Service News

Panda

4420 D 201 GH REAR SUSPENSION

Service solution for cases in which the vehicle leans to one side

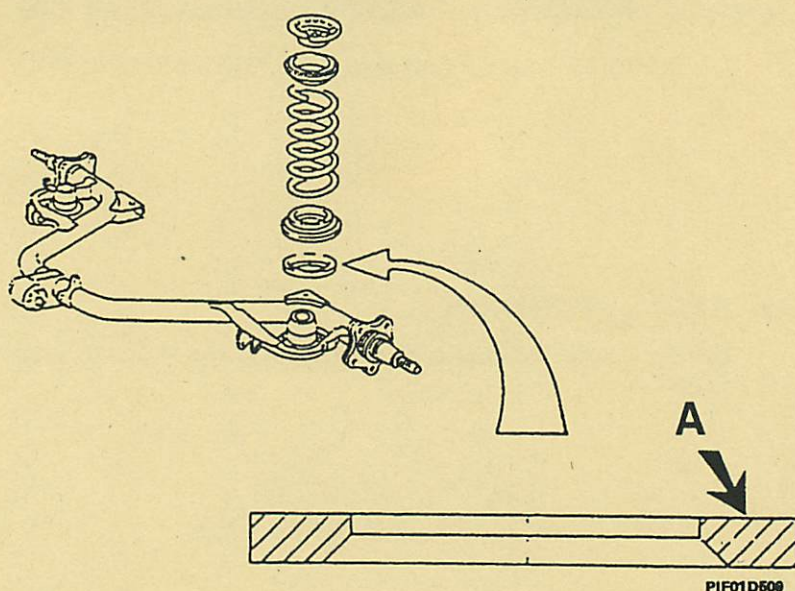
In running and order and static, the vehicle may tend to lean to one side on account of the particular sensitivity of this type of suspension to variations in the flexibility of the springs even within the tolerance range.

Insert spacer no. 46427846 (A in the diagram) under the rear spring on the side to which it is leaning.

With the vehicle in running order on a flat surface, detect the side to which the vehicle is leaning.

- Raise the vehicle and, supporting the rear axle with a hydraulic jack, release the rear shock absorbers from the axle.
- Lower the rear axle so that it is possible to insert spacer no. 46427846 under the spring on the side to which the vehicle is leaning.
- Refit the components removed in the reverse order to the removal.
